Service Bulletin

Bulletin No. 2017-12

Improved Power Trim Poppet Valves (PO Check Valves)

Poppet Seal Assembly Comparison

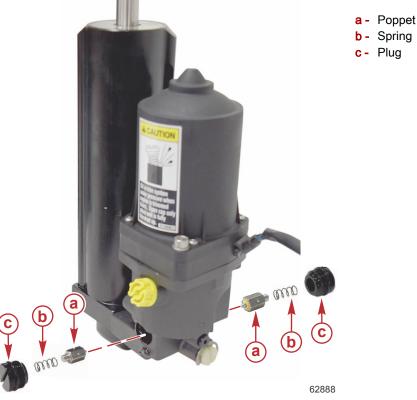
A new power trim poppet valve (pressure operated check valve) has been released which incorporates improved urethane face seals. This new poppet valve will help to reduce or eliminate the poppet valve related system leakage issues. These issues would include:

- a Original poppet valve assembly black colored seal face
- b New poppet valve assembly neutral colored seal face

75/80/90/100/115 FourStroke, 75/90/115/125 OptiMax, 75/90/115/125 2-Stroke (3 Poppet Valves Required)

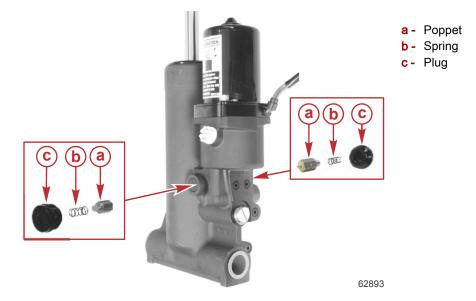
1. Replace the power trim poppet valves as outlined in the kit supplied service instructions.

2. Replace the power trim up-circuit/tilt pressure relief valve (poppet) as outlined in the kit supplied service instructions.

40/50/60 FourStroke, 55/60 2-Stroke (3 Poppet Valves Required)

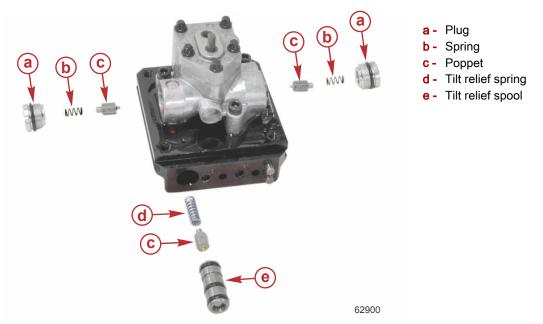
Replace the power trim poppet valves as outlined in the kit supplied service instructions.
